Subject: MHI's Response to US-APWR DCD RAI No. 915-6344 Revision 0 (SRP 09.02.01)

Response to Request for Additional Information No. 915-6344
Revision 0

RAI NO.: NO. 915-6344 REVISION 0
SRP SECTION: 09.02.01 – Station Service Water Systems
APPLICATION SECTION: 9.2.1
DATE OF RAI ISSUE: 3/29/2012

QUESTION NO.: 09.02.01-60

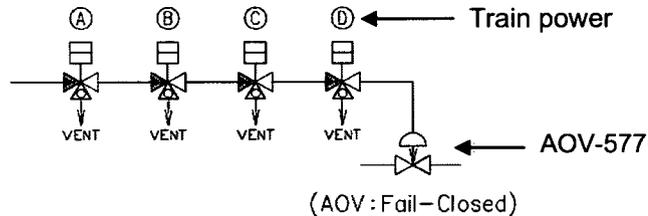
Related to COL Item 9.2(7), Comanche Peak, the COL applicant indicated in a January, 23, 2012, call with the NRC that ESWS safety-related to nonsafety-related boundary valve, AOV-577 (shown on Figure 9.2.1-1, Sheet 1) has four different power supplies.

1. The four different power supplies are not specifically described in the DCD, including Tier 1. The COL applicant stated that this item should be resolved in the DCD and not under COL Item 9.2(7).

2. AOV-577 logic states that this valve closes on ESWS pump stop. AOV 577 logic to close should be clarified and the DCD Failure Modes and Affects Analysis (FMEA) revised, DCD Table 9.2.1-2.

3. DCD FMEA should evaluate boundary valve AOV 577 not going full open. The DCD applicant should determine if there a safety feature for this valve to remain open. For example, if the valve fails closed during power operations, the UHS basin chemistry may not be able to be maintained.

4. DCD FMEA should evaluate VLV-544A/B/C/D (blowdown bypass) being open with single failure of AOV 577 not fully closing (which might occur if there were a bent valve stem).

1. AOV-577 has 4 pilot valves that are supplied electric power from different trains, as shown below. A, B, C and D Class 1E DC-buses power AOV-577, and when power is lost to any of the buses, AOV-577 closes.

2. AOV-577 is a fail-closed valve, and closes automatically on a low basin water level signal, ECCS actuation signal, UV signal or ESW pump stop signal. Closure isolates non-safety-related portions to maintain the required UHS basin inventory for a minimum of 30 days without makeup water. Valve closure also precludes system inventory drain down which may lead to water hammer at pump restart. The valve position is indicated in the MCR. As indicated in the response to Item 5, the valve is not included in the DCD failure mode and effects analysis (FMEA) because it is not part of the standard design.

3. The safety function of AOV-577 is to isolate the UHS blowdown line to ensure that the UHS basin inventory required for cooling the unit for a minimum of 30 days without makeup water is maintained. Either AOV-577 and HCV-010,011,012,013-S or AOV-576 A/B/C/D-S can perform the safety function to isolate the UHS blowdown line. Conversely, opening AOV-577 is not a safety function. If AOV-577 fails closed, the UHS basin water chemistry wouldn't be controlled; however, controlling basin water chemistry is not required during an accident and AOV-577 is designed to close during an accident, as stated in the response to Item 2. The function of AOV-577 for water hammer prevention is also not a safety function because it is not related to accident mitigation. As indicated in the response to Item 5, the valve is not included in the DCD failure mode and effects analysis (FMEA) because it is not part of the standard design.

4. The postulated failure resulting in a blowdown bypass could be terminated by operator action. The effect of uncontrolled blowdown for 30 minutes on basin inventory is insignificant. For example, Comanche Peak Nuclear Power Plant, Units 3&4 COLA Rev. 3, Part 3, Table 3.3-1 describes that the maximum blowdown flow rate is 515 gpm per unit. Blowdown water volume for 30 minutes is 15,450 gallons, which is less than 1% of the total required basin water volume of approximately 8.40 million gallons per unit. When EWS-HCV-010, 011, 012, 013-S or VLV-544A/B/C/D (blowdown bypass valve) is open with a single failure of AOV-577 not fully closing, an operator has sufficient time to close the appropriate valve(s) to terminate an uncontrolled blowdown.
